July 19, 2022

#### RE: Starbucks – Coors & Brayton Grading and Drainage Plan Engineer's Stamp Date: 06/24/22 Hydrology File: J11D017

PO Box 1293	Based upon the information provided in your submittal received 06/30/2022, the Grading & Drainage Plan <b>is not</b> approved for Building Permit. The following comments need to be addressed for approval of the above referenced project:		
Albuquerque NM 87103	1. It is unclear what is being constructed and what is existing. It is not Hydrology's job to guess and if I can't tell, I know the contractor will not be able to tell as well. In places the line work for the existing is the same line weight as proposed. The only items that stands out are the proposed contour lines. Is the proposed pavement asphalt? At the edge of pavement at places there is a call out of top of curb and at others there is just a spot elevation but the line work is the same at both spots a single lint it is not clear where the proposed curbing onsite starts and where it stops. The standard for a curb is a double line. Please clean this up.

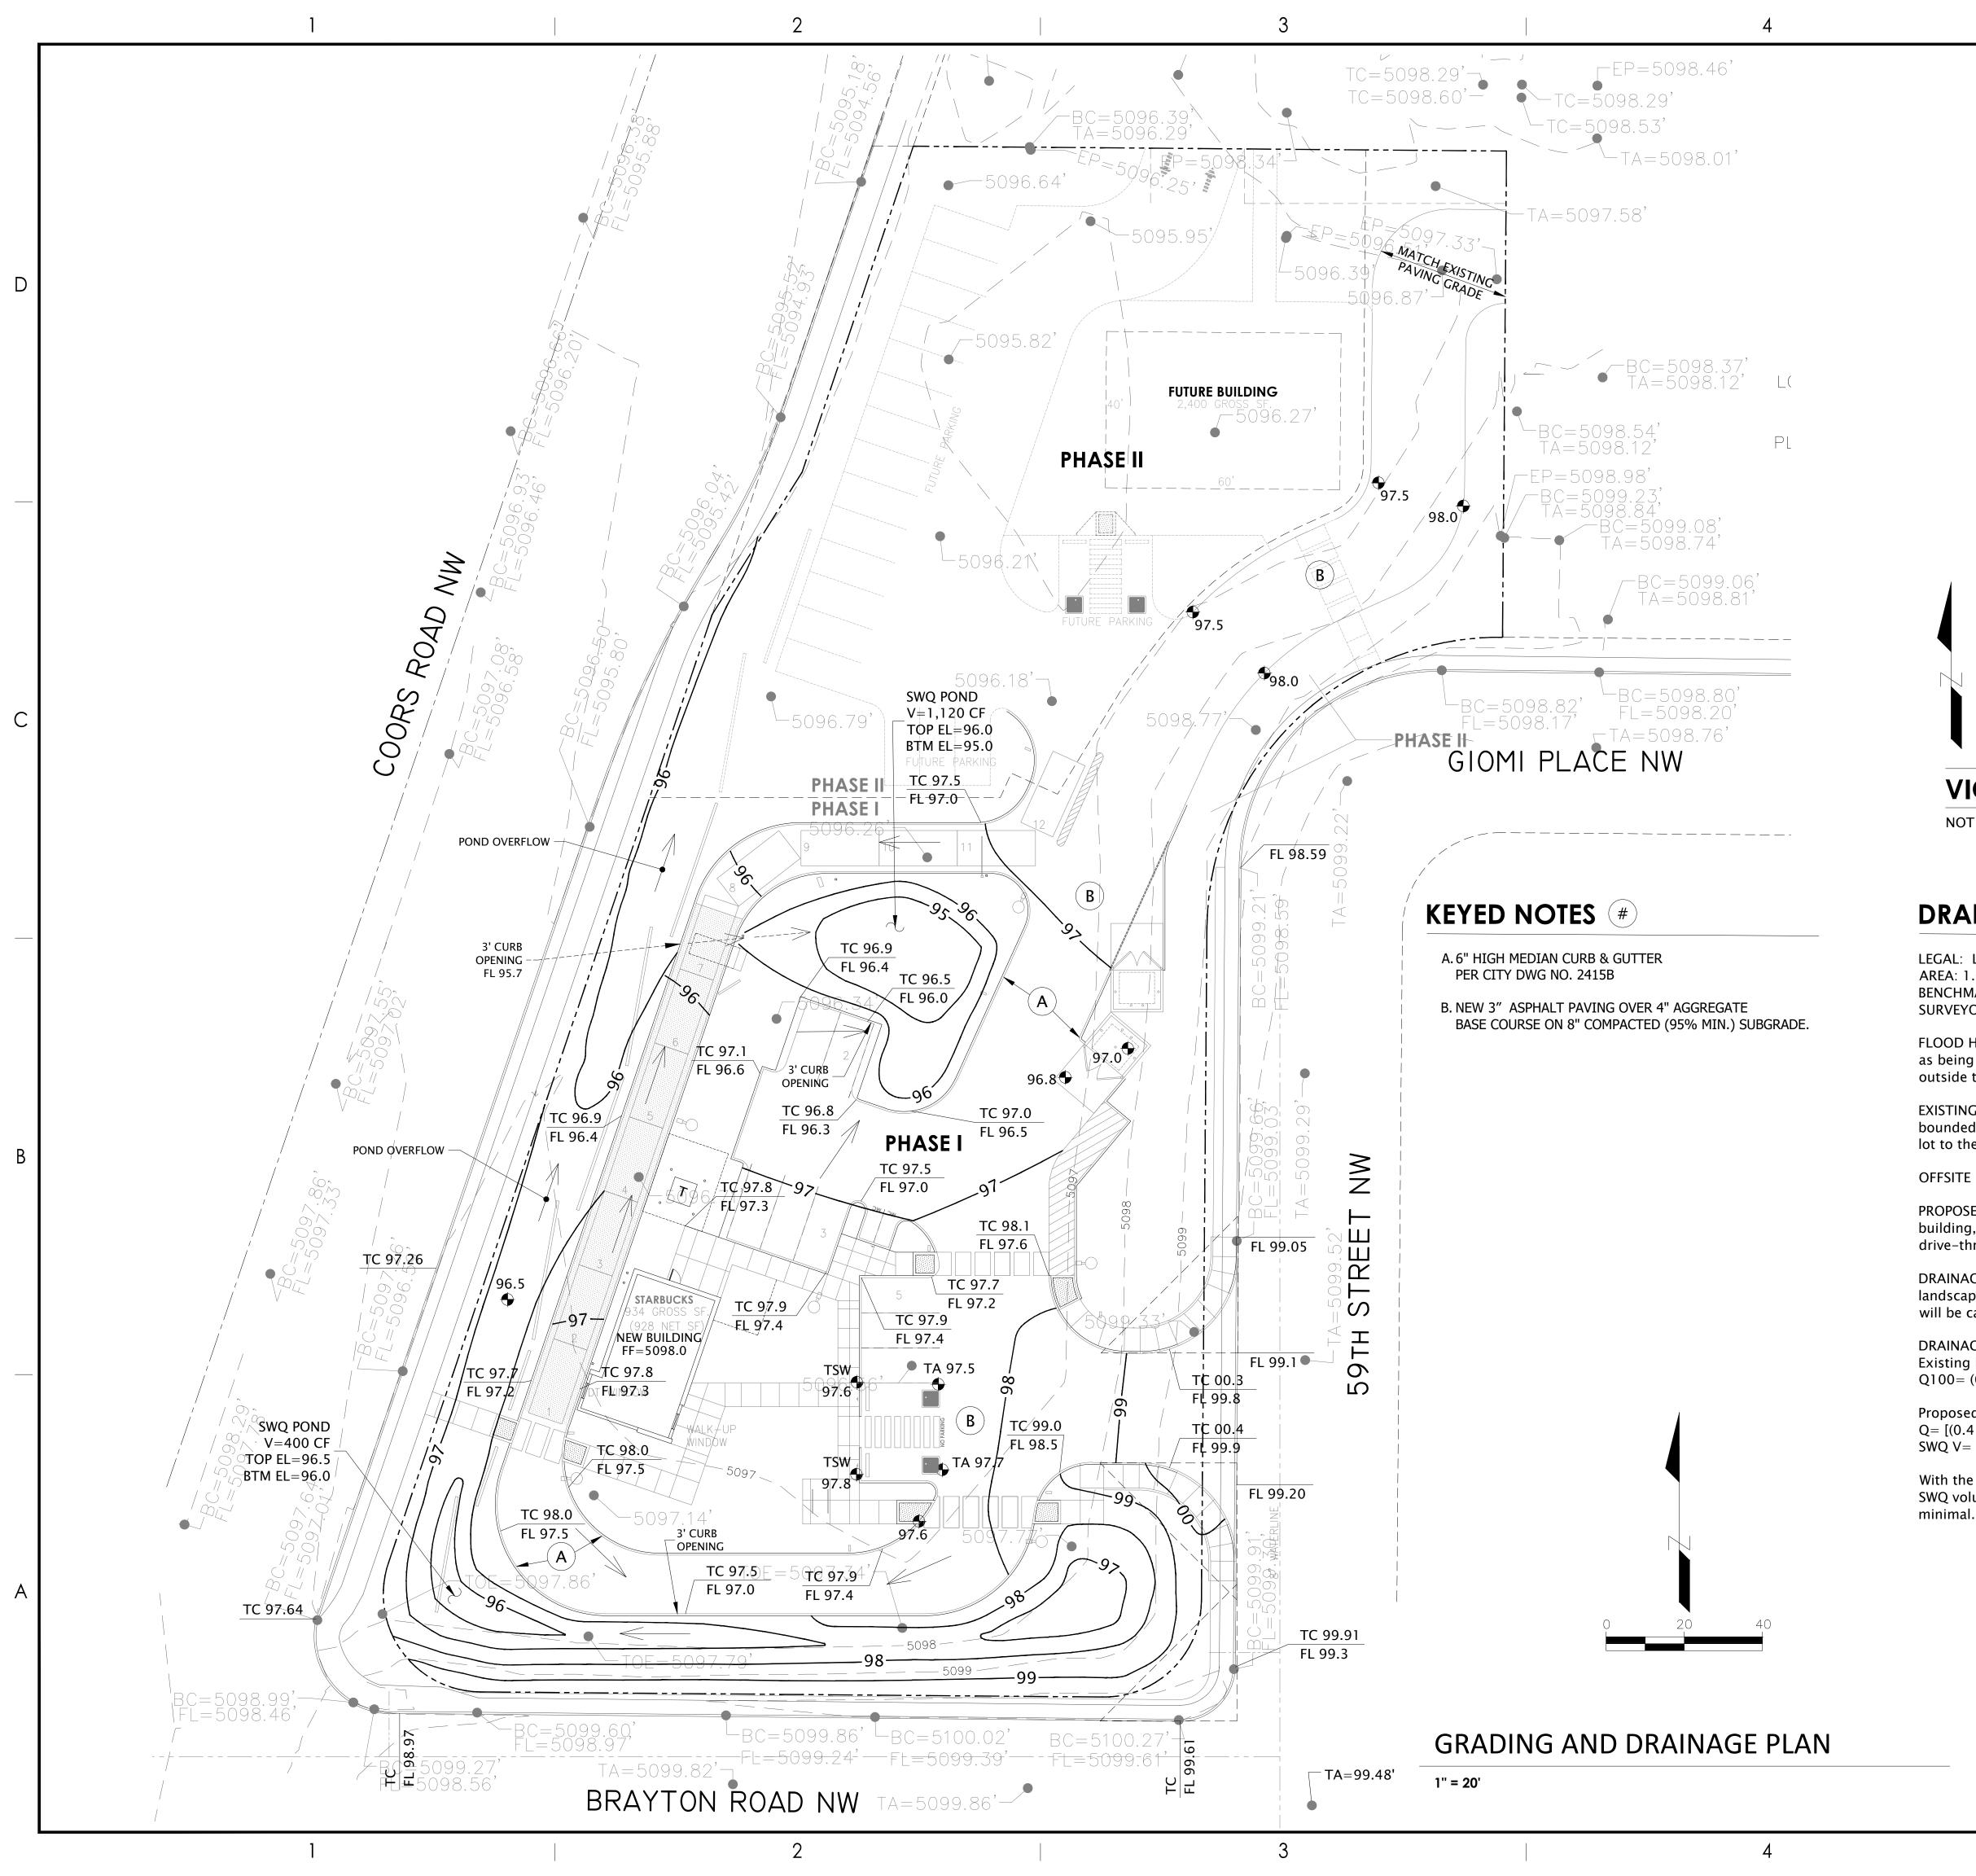
www.cabq.gov	<ol> <li>It appears that there is proposed grading and construction work being done on a tract of land that is not owned by the project Owner. Provide written and signed permission from the adjoining property owner for work on their property. This should be notarized.</li> <li>Please call out the stormwater quality ponds and include the provided SWQV and elevation of the SWQV and the bottom of the pond elevation. There is a pond at the southeast corner that does not have drainage going to it so it is not needed. The pond on the southwest corner discharges to the northeast but there needs a pipe under the connectivity sidewalk for drainage.</li> </ol>

4. Where does the entire site drain? The SWQ pond needs a spillway and the site needs to somehow drain to 59th Street or Brayton through a sidewalk culvert or pipe through the curb. Please revise the grading.

5. Please provide the weir calculations, per DPM Article 6-16(A), for the 3ft curb cuts. A coefficient of 2.7 is typically used for the weir equation  $Q = CLH^{2/3}$ .
